General Nuclear System	REGULATORY OBSERVATION RESOLUTION PLAN RO-UKHPR1000-0023	Rev.: 0	Page: 1 / 15
		GDA-REC-GNSL-005854

REGULATORY OBSERVATION Resolution Plan	
RO Unique No.:	RO-UKHPR1000-0023
RO Title:	Demonstration of Diverse Protection for Frequent Faults
Technical Area(s)	Fault Studies
Revision:	0
Overall RO Closure Date (Planned):	2021-03-31
Linked RQ(s)	RQ-UKHPR1000-0471
Linked RO(s)	RO-UKHPR1000-0001; RO-UKHPR1000-0017; RO-UKHPR1000-0021
Related Technical Area(s)	Control & Instrumentation, Electrical Engineering, Mechanical Engineering, Cross-cutting
Other Related Documentation	
Scope of Work	
<p><u>Background</u></p> <p>As mentioned in Safety Assessment Principles (SAPs) [1] FP.6, all reasonably practicable steps must be taken to prevent and mitigate nuclear or radiation accidents. The objective of diversity design is to augment the reliability of safety measure to avoid the Common Cause Failures (CCFs).</p> <p>SAPs [1] EDR.3 states that CCFs should be addressed explicitly where a structure, system or component employs redundant or diverse components, measurements or actions to provide high reliability. Considering that the fault sequence frequency of 1E-07 pa is the cu

Figure 1 Example for RO Action 2

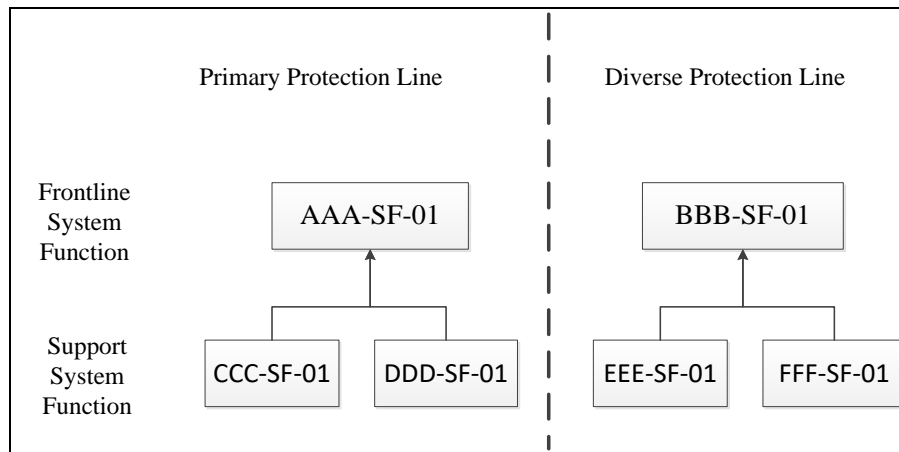
A general example for protection line configuration is shown in the Figure 1. To respond to Action 2 and 3, the following steps will be taken:

As shown in the Figure 1, BBB-SF-01 should be diversified with AAA-SF-01. The corresponding equipment, signals as well as I&C platform of AAA-SF-01 and BBB-SF-01 will be summarised and compared to make sure if any vulnerability or common part could directly lead to loss of both primary protection line and diverse protection line.

As shown in the Figure 1, CCC-SF-01 and DDD-SF-01 supporting AAA-SF-01 are necessary to be diversified with EEE-SF-01 and FFF-SF-01 that support BBB-SF-01 to avoid loss of both primary line and diverse line caused by the loss of common support system.
